Westlake Cycle Track Design Advisory Committee

Meeting #9 Summary

Wednesday, Nov. 19, 2014 5:30-8 PM

Figure 2: Sample cross section

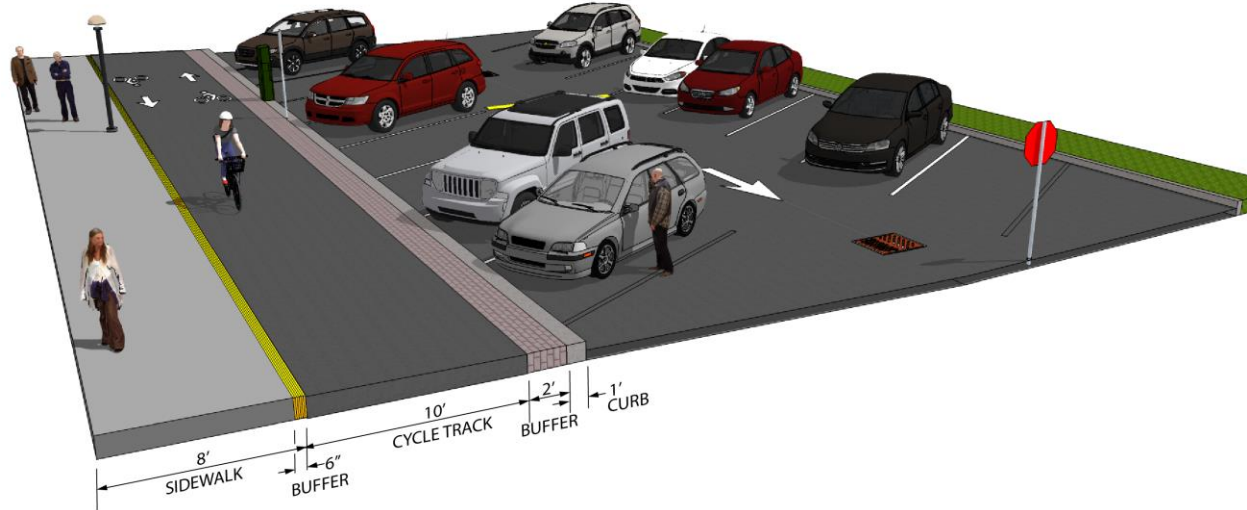
- Cam asked for the manufacturer of the rumble strip.
 - CJ said there are numerous manufacturers.
- CJ explained there will be a 1-foot curb for car overhangs and a 2-foot buffer between cars and the cycle track.

- Martin expressed concern that unloading from the trunk of a car would be dangerous if backed-in to a parking spot adjacent to Westlake Avenue N, as well as concern that it would be difficult to push a cart from the median between two parked cars.

- Peter asked for the pros and cons of perpendicular and angled parking.

- Cam asked if CJ was aware of the mobile marine repair businesses in the corridor who need to unload large, heavy items that can't fit between two cars.

- Andrew asked what the composition and purpose of the buffer between the cycle track and the parking area.
 - CJ said it would likely be made of stamped concrete, as brick is hard to maintain. The buffer will allow for a one foot car overhand and give pedestrians a place to stand before crossing the cycle track. Pay stations would also be installed in the buffer area reducing the number of times people would need to cross the cycle track.

- CJ noted that the median between the parking area and Westlake Avenue N is 6 feet wide, and that people currently unload in that area frequently, but that the team would look again at the dimensions in this area.

- CJ explained that the reasons for the proposed parking design are to keep people from unloading directly on the cycle track, to improve sight lines so bikes can see pedestrians and vice versa when they are walking between cars, and back-in parking allows more space to be dedicated to the drive aisle.

- CJ explained that perpendicular parking allows for more parking stalls, but requires a larger drive aisle. The design team is using perpendicular parking wherever possible, but in areas where the drive aisle is especially narrow, angled parking is used.

- CJ said the team was aware of this need and could designate larger spaces or load zones to fit this need.
- Warren asked whether there would be speed bumps for vehicles or bicyclists.

Figure 3: Sample cross section with pedestrian crossing

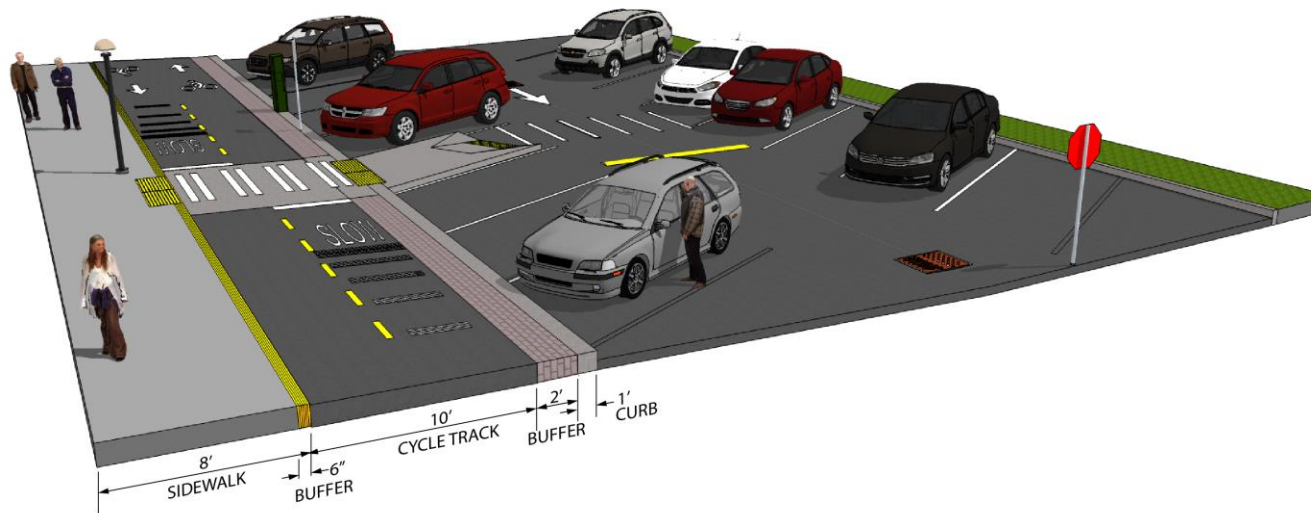
- Thomas asked if the crossing would have a raised table top when extending into the parking area, similar to the Beacon Hill Light Rail Station.
 - CJ said it would be raised in the parking area and drop down at the curb ramp.
- Cam asked why a curb was used rather than wheel stops for cars in the parking area, as wheel stops allow people to push carts through. He noted trailers would have difficulty navigating the curb.
 - CJ said wheel stops are easily damaged and moved. In addition, the curb helps prevent people from driving onto the cycle track. The alignment maintains all existing driveways, which is what trailers would utilize.

Figure 4: Driveways #1-5, Design progress

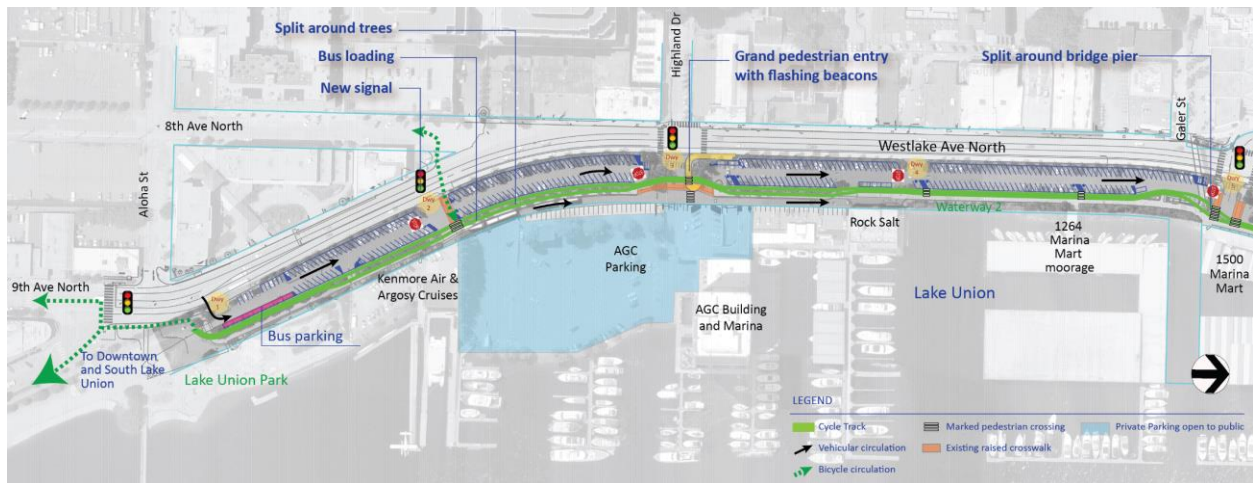
- Warren clarified that Ninth Avenue N is a signalized crossing.
 - CJ confirmed this, noting this icon had been erroneously left off the image.
 - Martin clarified that the red dots on the image signify stop signs.

- Warren asked where load zones would be located and clarified that the 327 parking stall figure applied only to this segment.

- Amalia clarified that the image showed the treatment only for Highland Avenue N, not for all intersections.
 - Devor suggested that the pedestrian-sensing bollards be relocated from where the image showed them to detect people walking from the AGC Building.

- CJ said no loading zones had been identified for this segment, and confirmed that 327 parking stalls applied to this segment only.

- CJ agreed this was a good idea.

Figure 5: Driveways #5-9, Design progress

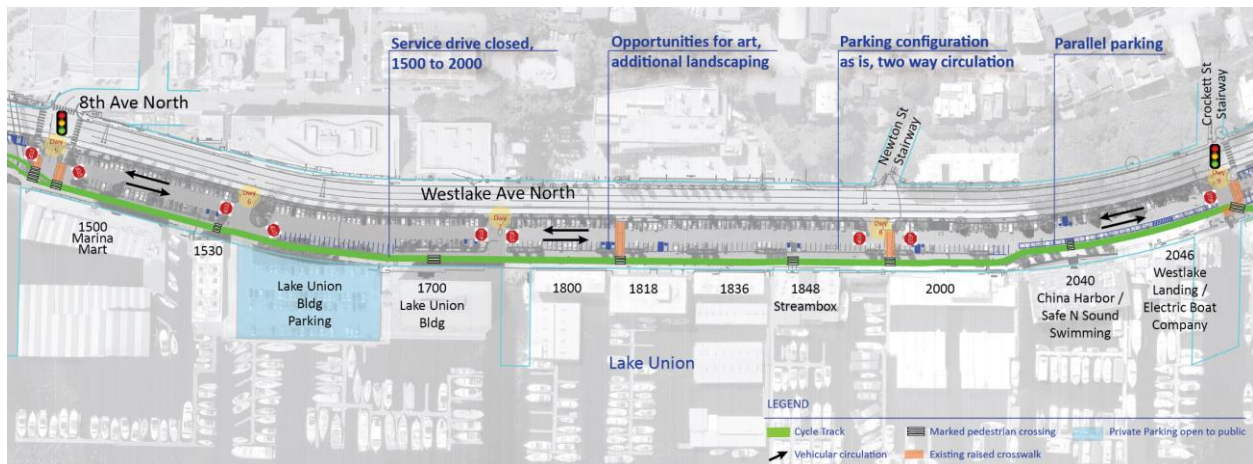
- Cam asked if additional ADA spaces would be added.
 - CJ explained that they would maintain all existing spaces.
 - Dave asked what would keep bikes from riding in the drive aisle in this area, since it would be two-way.

- Martin noted that the image erroneously listed the address as 20,000 Westlake Avenue N as opposed to 2,000.
- Cam asked why the service lane would be closed in front of the Lake Union Building.

- CJ said there would be stop signs and they could consider adding more speed humps to the drive aisle in this area. Rumble strips are not planned for the drive aisle.

- CJ explained the service lane space is needed for the sidewalk and cycle track, and that outreach to impacted businesses in this area had been conducted.

Figure 6: Driveways #9-14, Design progress

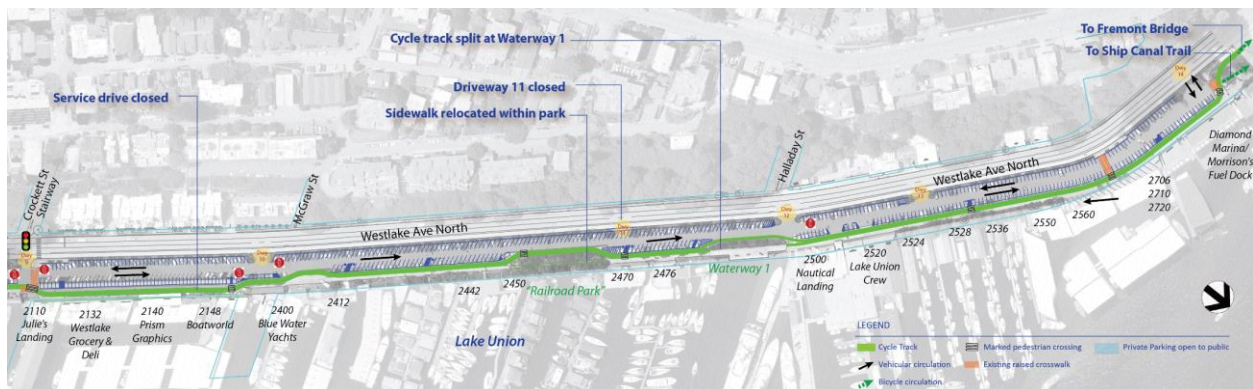
- CJ explained the design team is considering hatches to allow fuel hoses to run underneath the cycle track.
- Amalia clarified that Driveways #10-12 would have back-in angle parking.

- CJ confirmed that this would be present on the west side, but was not yet shown on the drawing.
- Dave noted that Driveway #11 is too tight for fuel trucks to use, and thus they utilize Halladay Street.

- Cam asked if entries and exits would be widened.
 - CJ said the driveways would not be reconfigured, but that if problems arose this could be reevaluated.

- Warren noted that the split in the cycle track at Waterway #1 could make the proposition of a hatch for fuel hoses under the cycle track difficult because of the distance.

- CJ said the project team may consider splitting the cycle track farther south.
 - Cam noted that Lake Union Crew has a 75-foot trailer they need to bring through the parking area.

- CJ said the current driveway configuration would be maintained.
- CJ noted the project team is still working on the north end connection. They plan to meet with Dave Morrison to ensure access is maintained for his fuel trucks.
